## PCN – Process Change Notification

Change:	GSA.8821.B.301111
Date:	2017/05/11
Author	Haley Tsai

Model#	Part Number	Changes
I-Bar Penta-band Cellular Antenna 3m RG174 SMA(M)	GSA.8821.B.301111	<ol style="list-style-type: none"> <li>1. Amend Package Rule.</li> <li>2. Amend tolerance of heat shrink tube.</li> <li>3. Amend double sided adhesive model</li> <li>4. Amend label material.</li> </ol>

#### New drawing

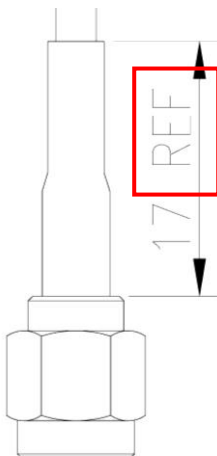
Double Sided Adhesive (Gray Foam)	001011J000020A	3M 1600TG	White Liner	1
GSM Label	001013K010051A	PEPA	Blue	1

**Old Package**

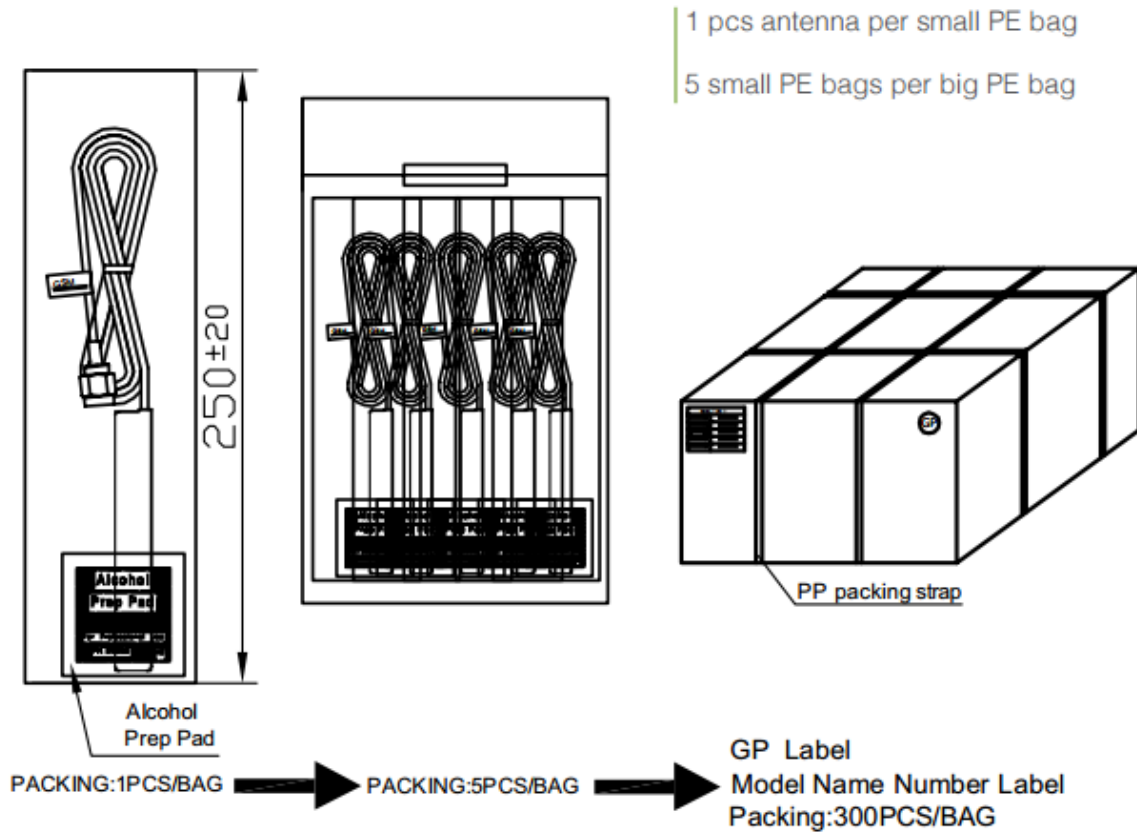
1. Amend Package Rule.
2. Amend tolerance of heat shrink tube.
3. Amend double sided adhesive model
4. Amend label material.
